Donald Insall Associates
Chartered Architects and Historic Building Consultants

C COPYRIGHT & DESIGN COPYRIGHT & DESIGN RIGHT 2008	PROJECT/SITE ADDRESS: ROCHDALE TOWN HALL TOWER LIFT SHAFT	GLASS & GENERAL www.glassandgeneral.com Unit 4 Heathway Industrial Estate Manchester Way Dagenham Essex	REVISIONS		DATE 17/12/22		DRAWN by RZH	
			01 - Details changed21.12.2022		CHECKED byProject M.			
			02 - Dimensions & details changed02.01.2022		SCALE 1:30@A3		Rev. 02

DRAWING REF. 01			
	TEL:	Rm10 8PN Tel: 0845 371 4450 Fax: 0845 371 4455	Note: CDM regulations will apply to status approval of drawings and manufacture will only commence on receipt of 'A' status approval of drawings issued. C = TO BE AMENDED - Drawings to be resubmitted. B = APPROVED WITH AMENDMENTS - Drawings to be resubmitted with final amendments included. A = APPROVED FOR PRODUCTION, NO COMMENTS - Procurement of materials, manufacture and installation to commence.		DRAWING TITLE Plan. Section 1-1

Section 7-7. Part 3 of 3

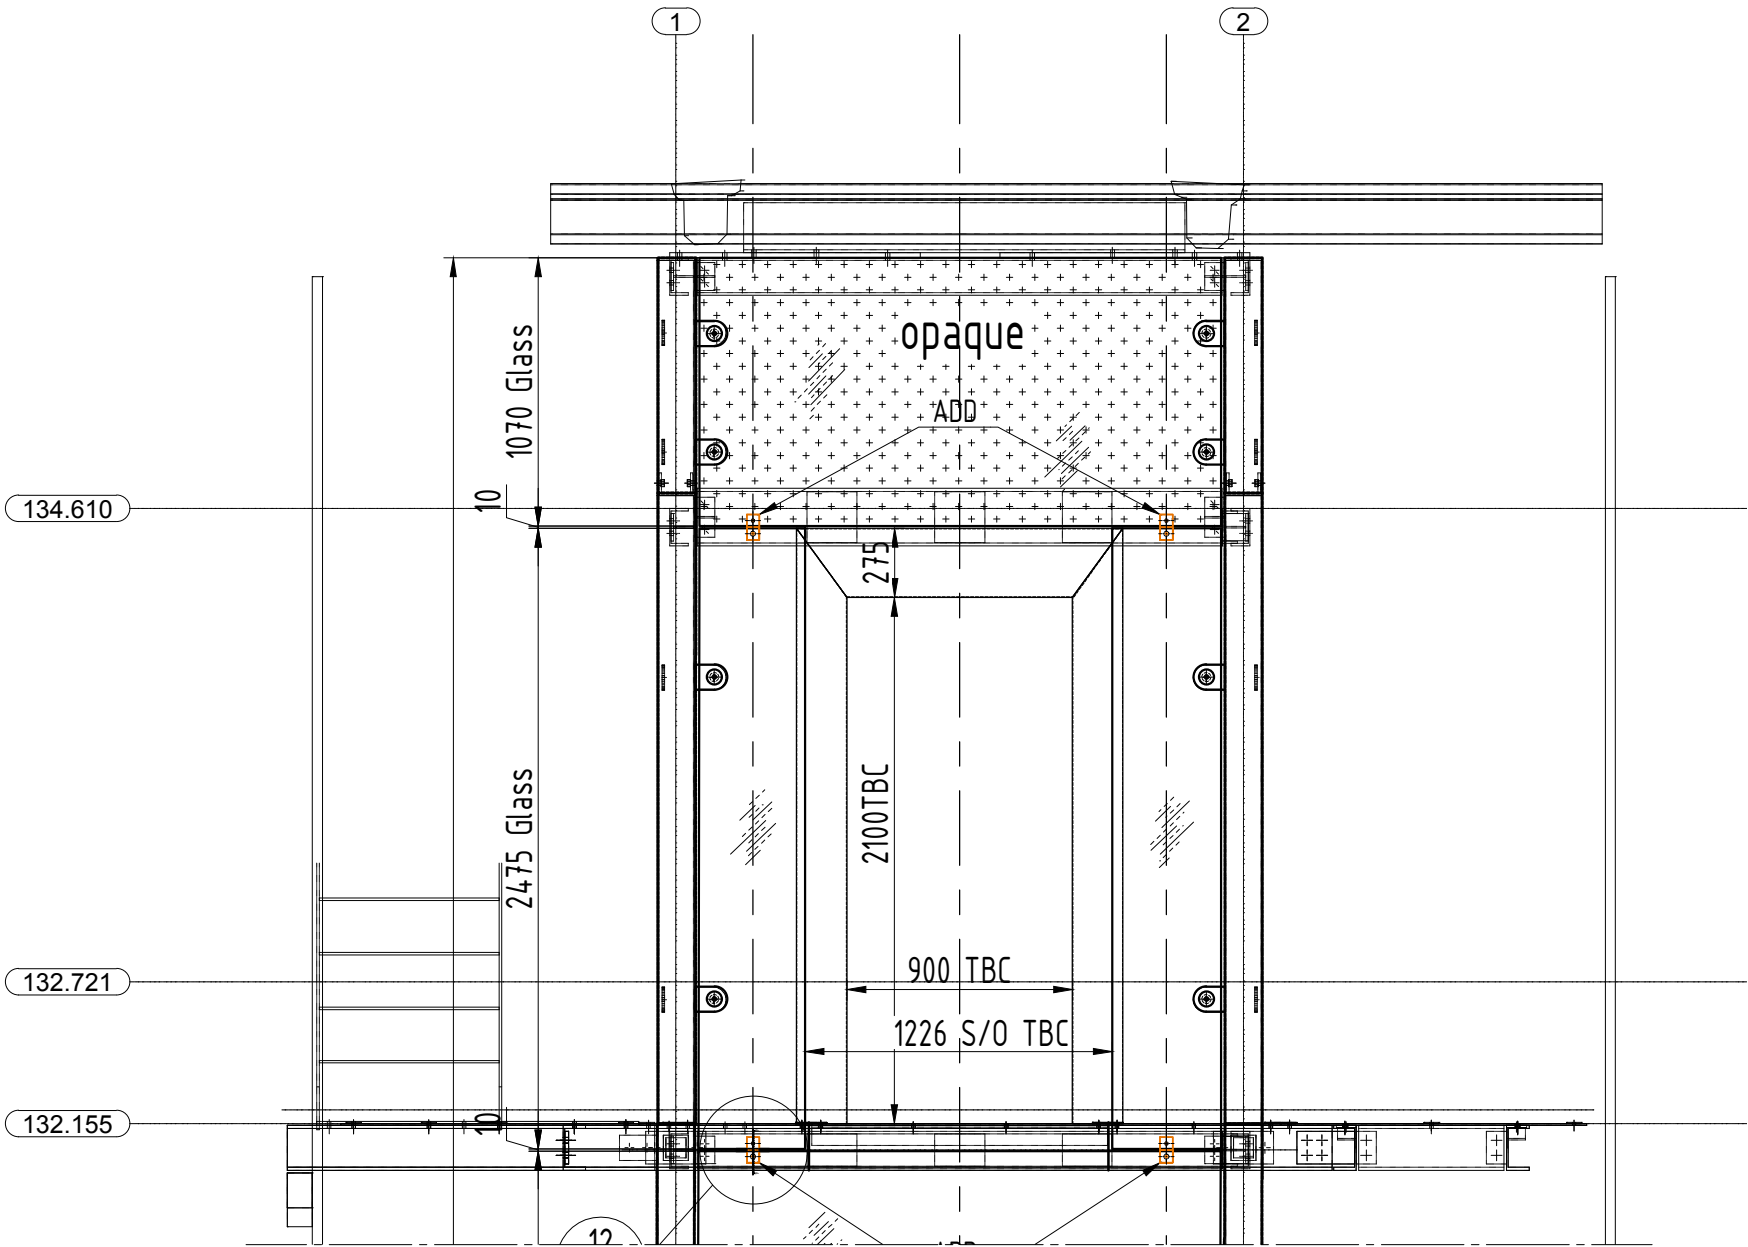
Approved on the basis a metal architrave is provided in Rymex bronze to close the gap between glass and lift shaft door installation. Details to be reviewed and agreed on site post installation of the glazing.

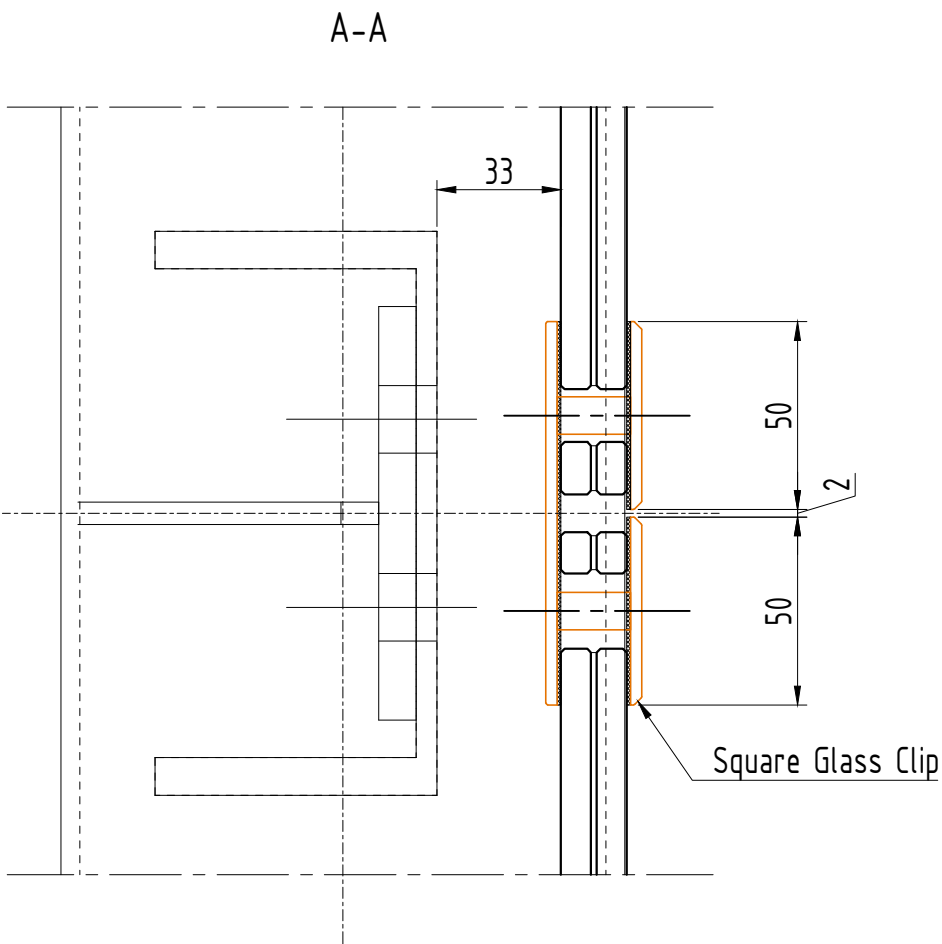
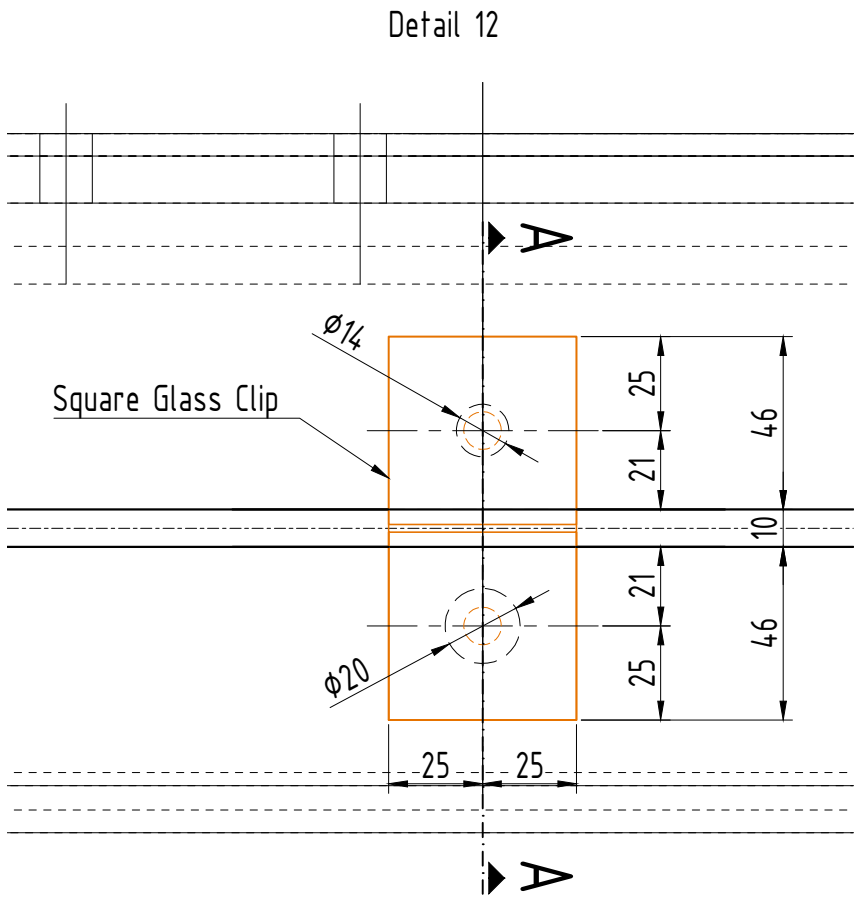
Silicone to be grey to match metal frame - sample to be approved prior to application.

Aluminium profile to be powder coated RAL 7022.
